|  DOA Nr.: EASA.21J.025 | Technische Mitteilung / Service Bulletin | Dokument Nr.: SB-AT01-030 |
| | Muster / Type: AT01 Nr. / No.: AT01-030 | Ausgabe/Issue: A.01 Seite/Page: 1 of 3 |

Inspektion des Wasserkühlers auf ausreichend Abstand zur Cowling und eventuelle Beschädigung / Inspection of water radiator for sufficient spacing and possible chafing damage

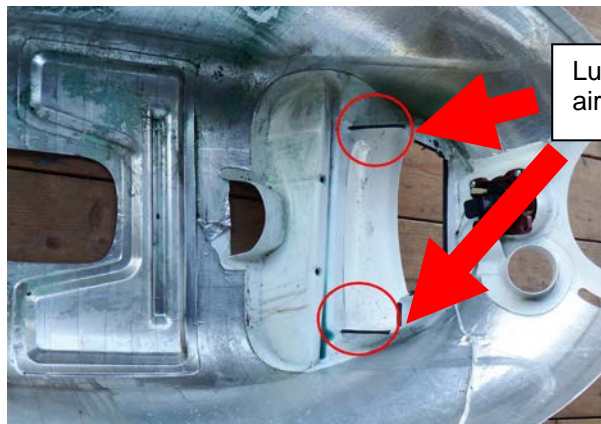
- (1) Inspection of water radiator and lower cowling (see pictures in annex)
- (2) In case of positive findings, trim (e.g. by grinding) GRP-web of air-duct and renew edge protection, so that a spacing of 1 up to 3 mm between radiator lower area and air-duct edge protection is ensured.

unterer Bereich des Wasserkühlers / lower area of water radiator

Luftkanal /
air-duct

Kantenschutz /
edge protection
